Work Order ID 131404

Item Name: Replacement Skidtube, High Gear with Standard Wearplates Fits LH or RH

DRAWING NO. D2650	TITLE 206/407 SKIDTUBE ASSEMBLIES	REV. F	DART AEROSPACE LTD ENGINEERING ORDER		D.E.O. NO. D2650-F-1	SHEET NO. SHEET 1 OF 1	SCALE NTS
DRAWN <i>[Signature]</i>	CHECKED <i>A.P.</i>	MFG. APPR. <i>[Signature]</i>	APPROVED <i>[Signature]</i>		DE APPR. <i>[Signature]</i>		
DATE 12.10.12	DATE 12.10.22	DATE 12.10.22	DATE 12.10.22		DATE 12.10.22

CHANGE C'BORED WELDED CROSSBOLT SPACERS TO SWAGED SPACERS

DETAIL G

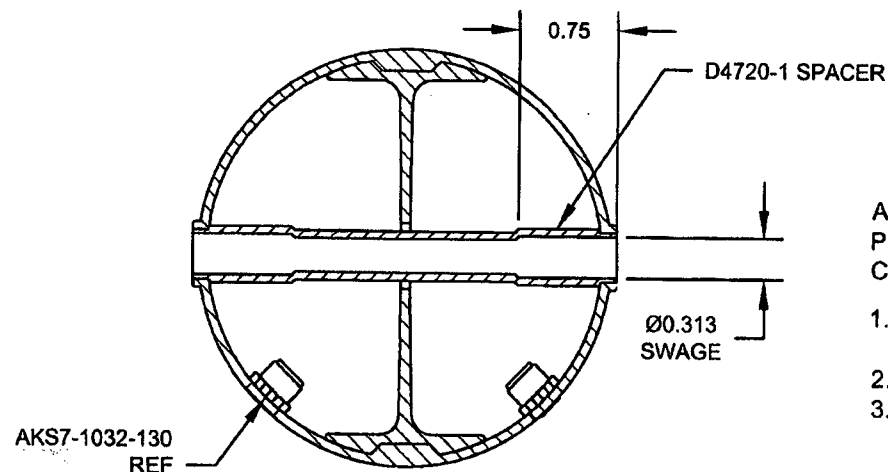
WAS:

17	18	19	23	D2649	CROSS BOLT SPACER
----	----	----	----	-------	-------------------

ADD DETAIL G BELOW, WHICH IS THE SAME SECTION VIEW AS DETAIL D OF DWG.
C'BORED HOLES ARE **NOW SWAGED** PER DETAIL G BELOW. FOR THE Ø0.375 HOLE THAT IS NOT C'BORED, WELD PER DETAIL D OF DWG (SEE AMENDED DETAIL B FOR REFERENCE).

AMENDMENT TO DETAIL B
NOT TO SCALE

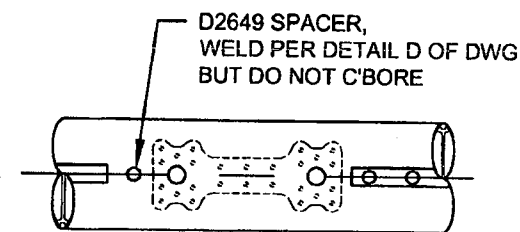
FOR Ø0.375 HOLES ONLY
FOR HOLES THAT ARE CURRENTLY C'BORED ONLY
NOT TO SCALE
